Certificate of Appropriateness

3136 W. STATE ST

Concordia HD

PTS ID 114440 COA: overall rehab and window replacement

1 NORTH BUILDING ELEVATION - DEMOLITION
SCALE: 1/8" = 1'-0"

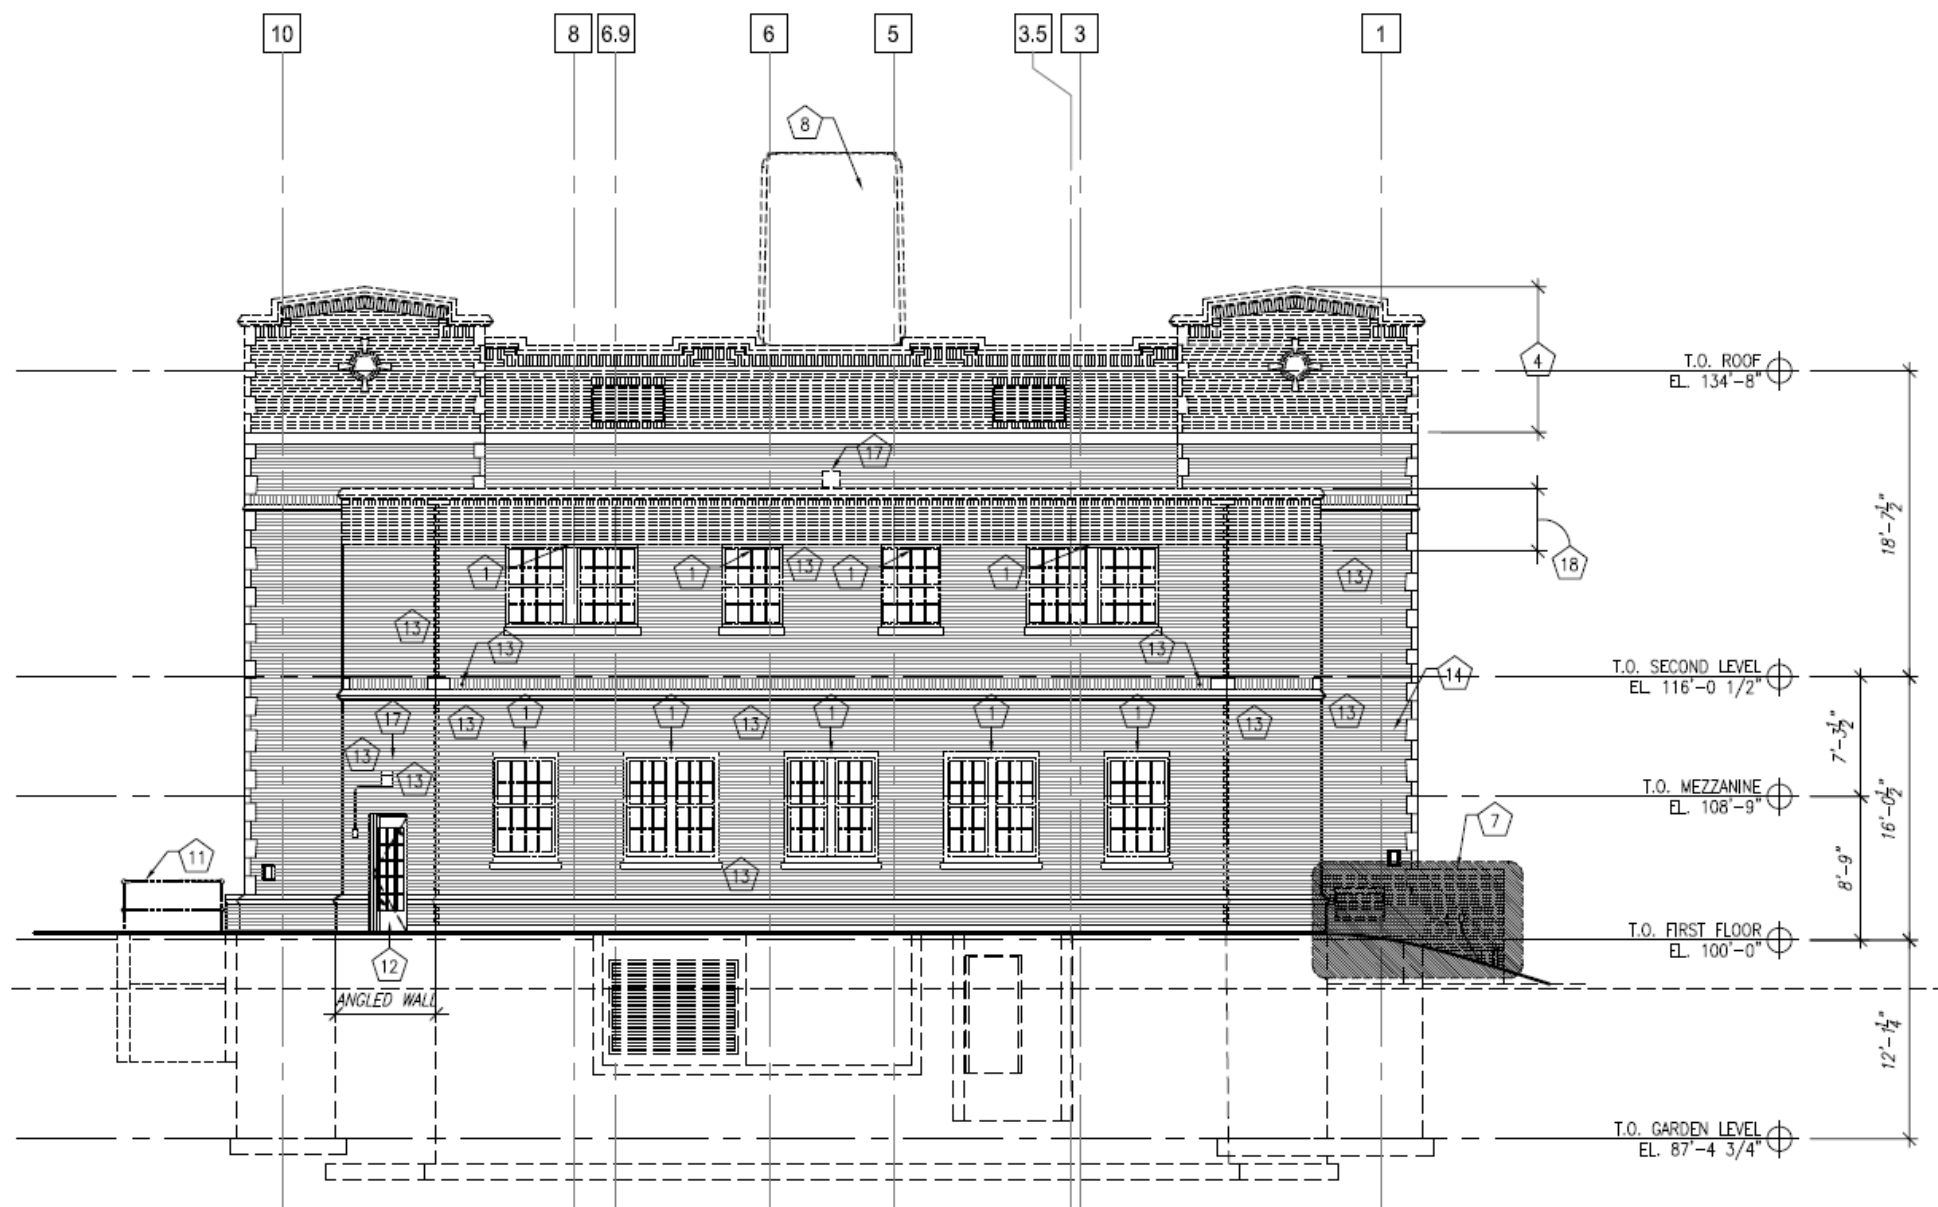
Replace door and transom with metal replicas due to kitchen vent insertion. Staff prefers a better door, but is otherwise satisfied with metal here.

Demo box-
like
addition

Remove Chimney

ROOF CONSTRUCTION NOTES

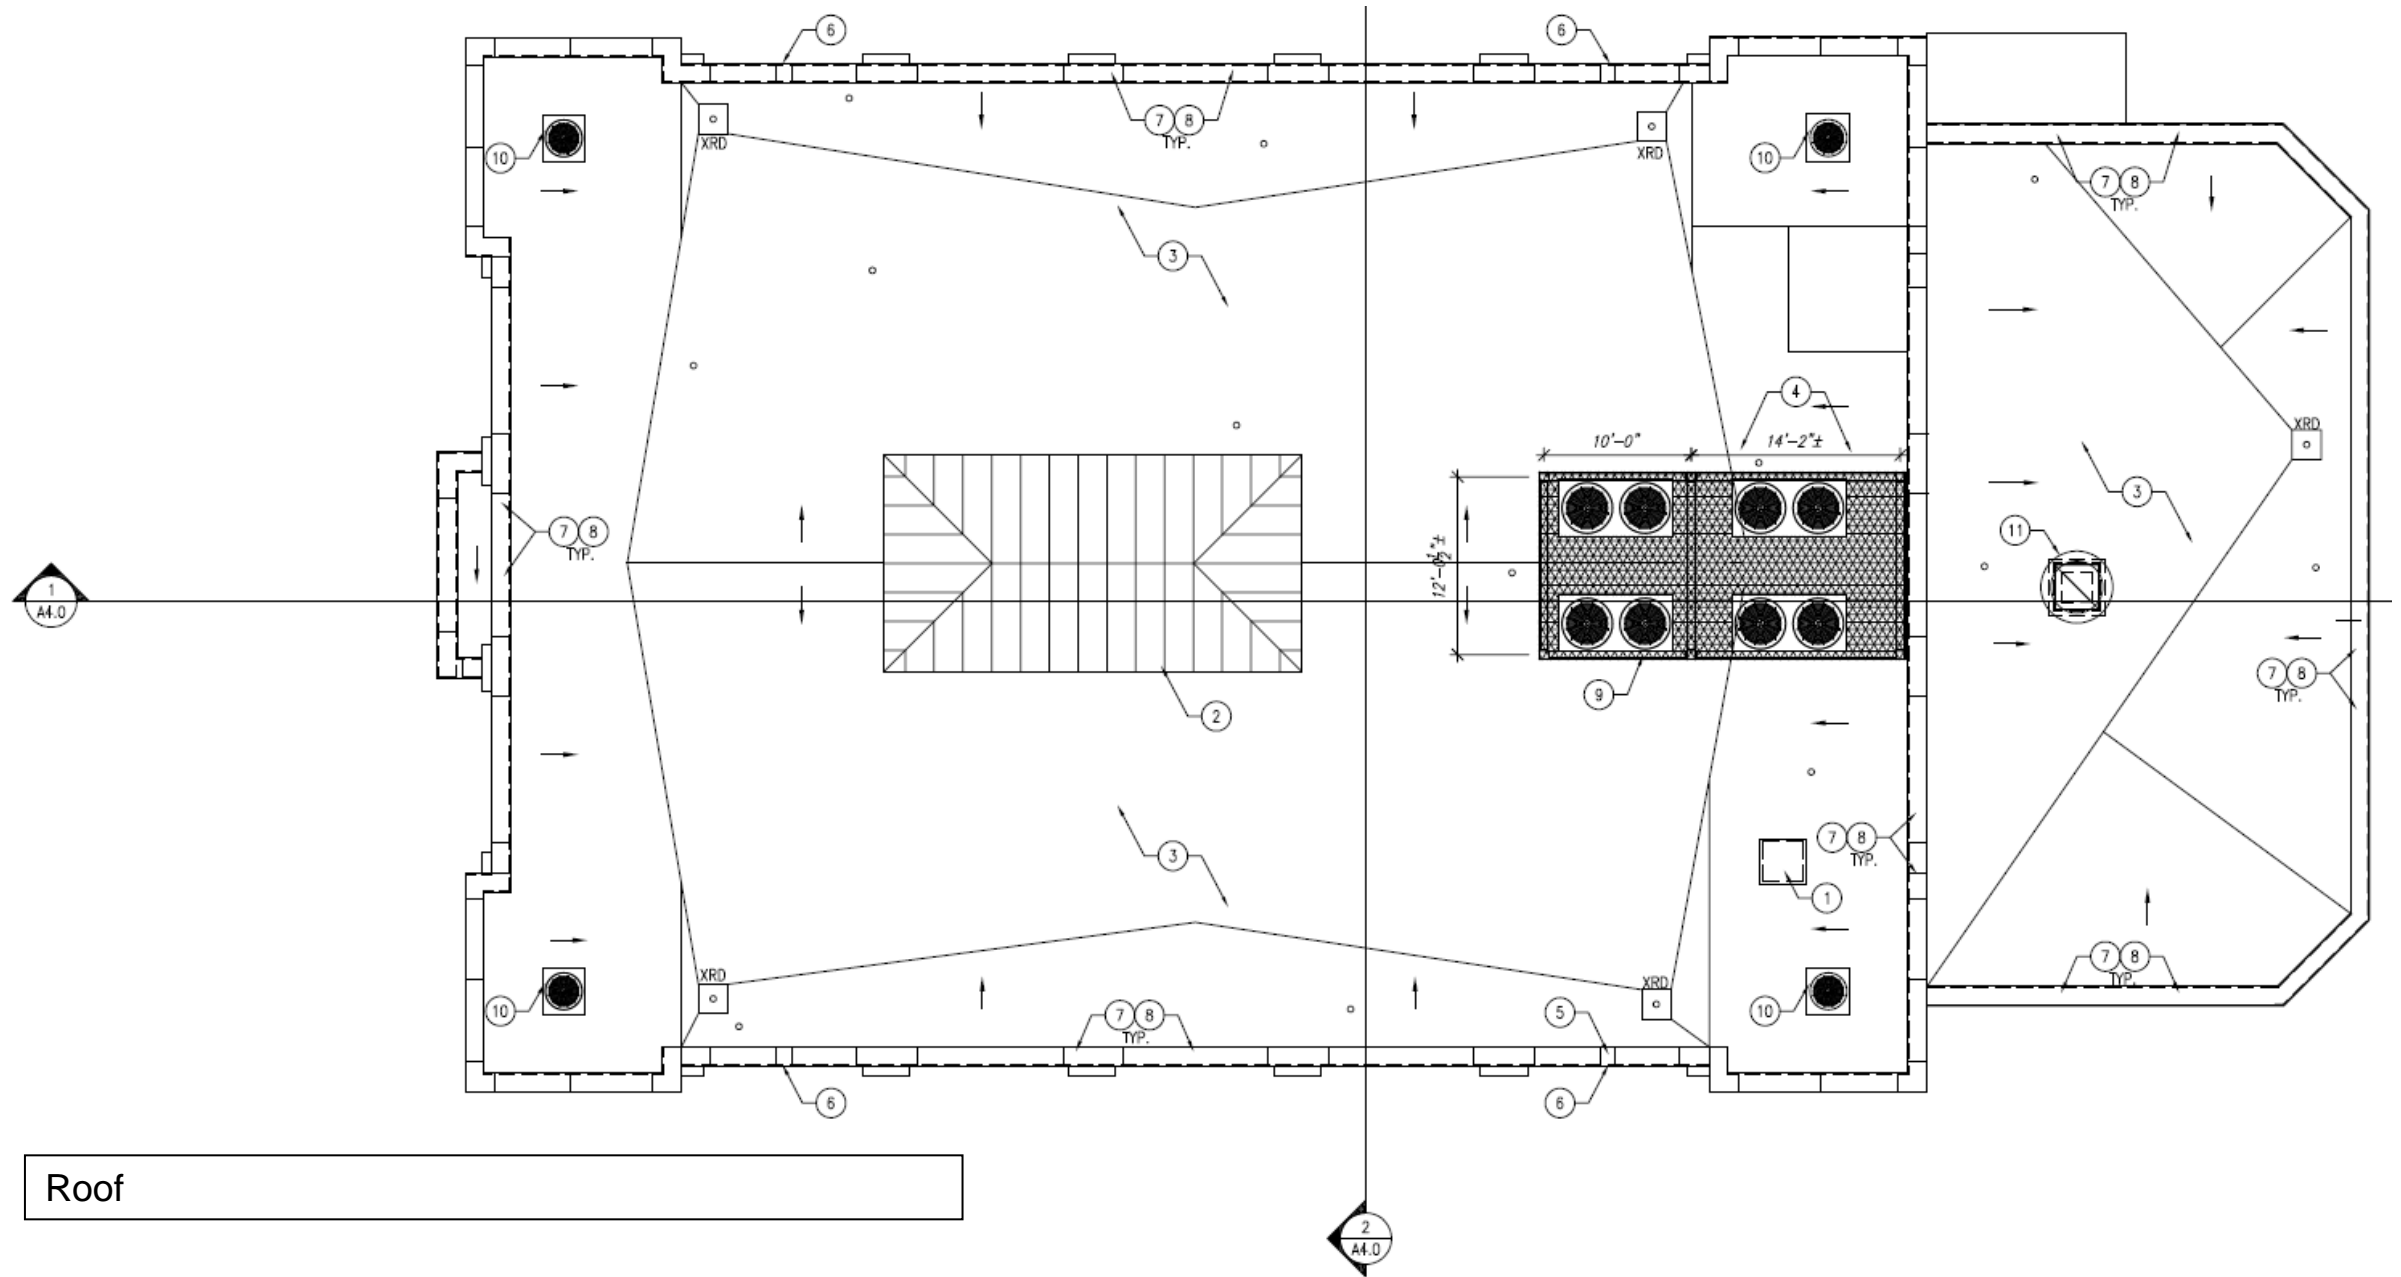
Skylight work not approved at this time. More information is required.
